MIDTOWN AT MACQUARIE PARK, IVANHOE

STAGE 1B LANDSCAPE WORKS
TENDER DOCUMENTATION

04 PL02/03/09/10 - GROUNDCOVER PLANTING
SECTION - Scale: 1:10@A1

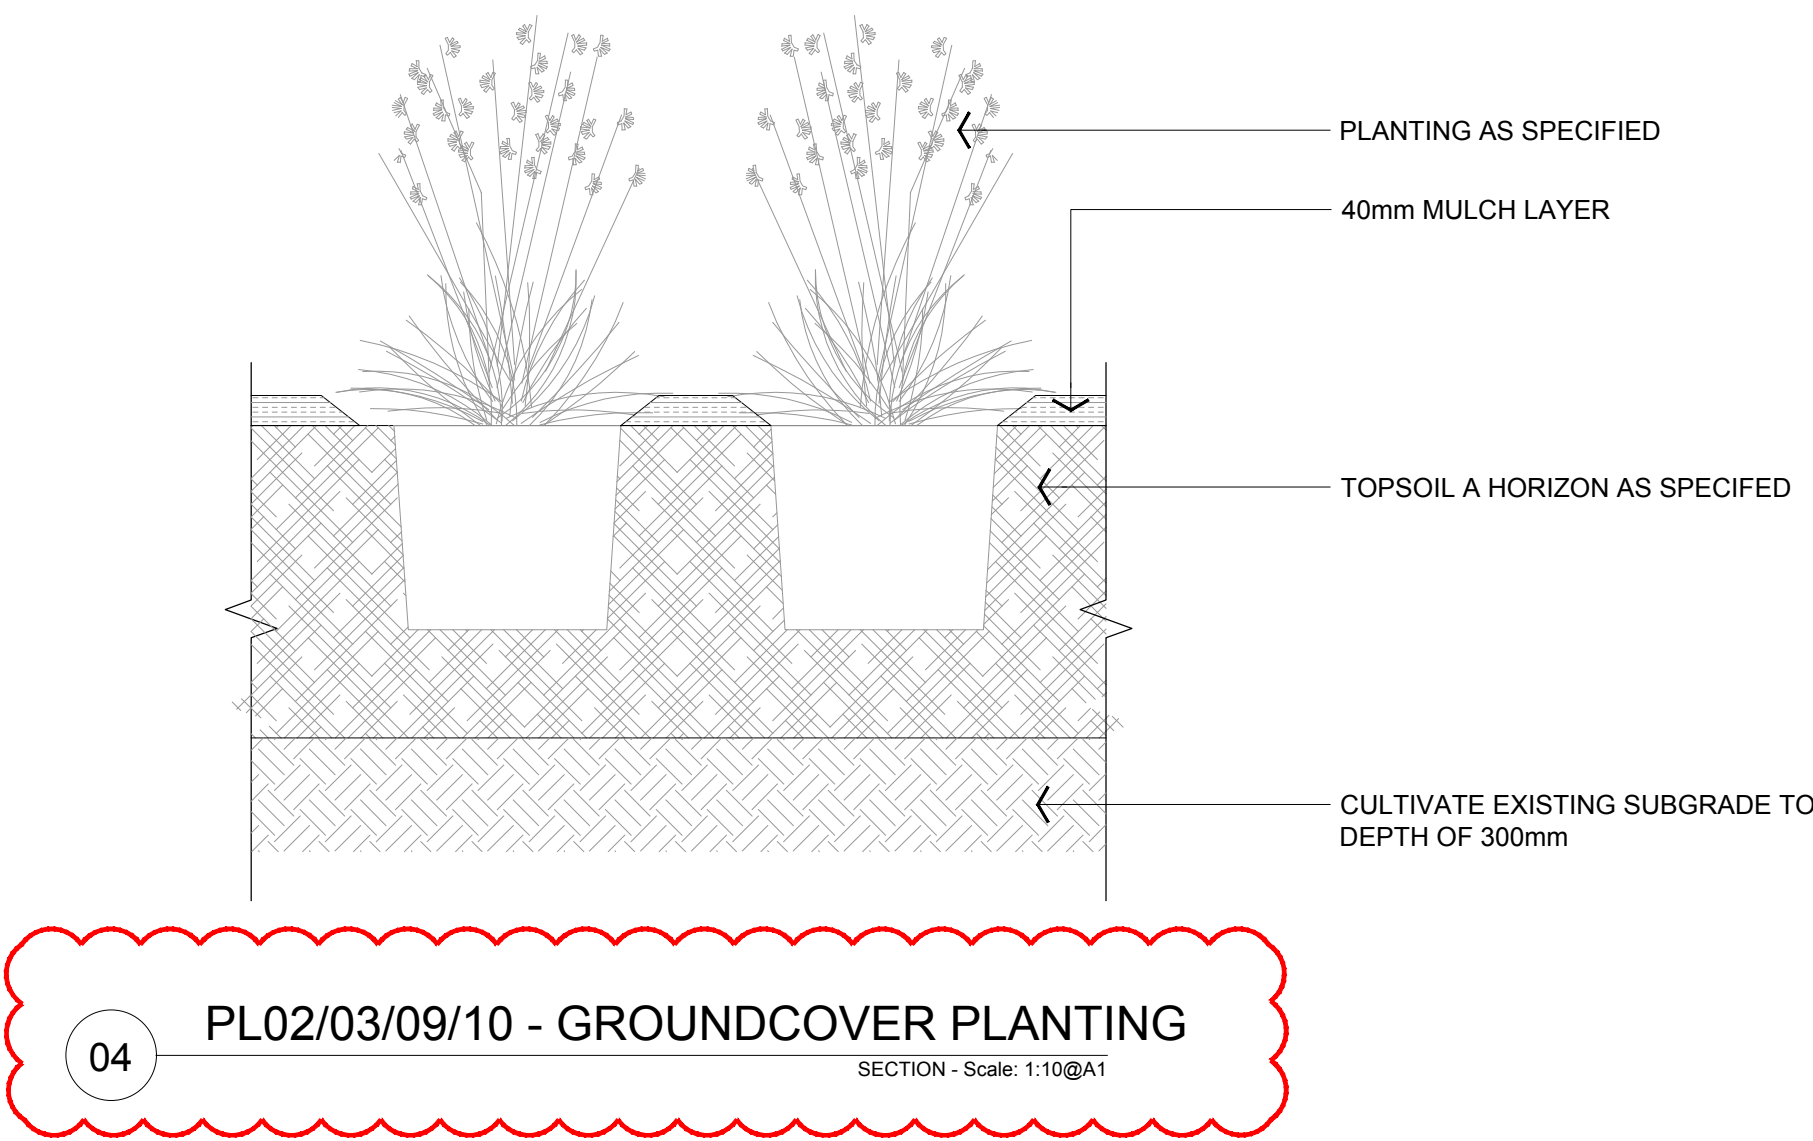
DETAIL DISCONTINUED
REFER TO MATERIAL AND FINISHES SCHEDULE

UPDATED TO REFLECT RELEVANT PLANTING MIXES
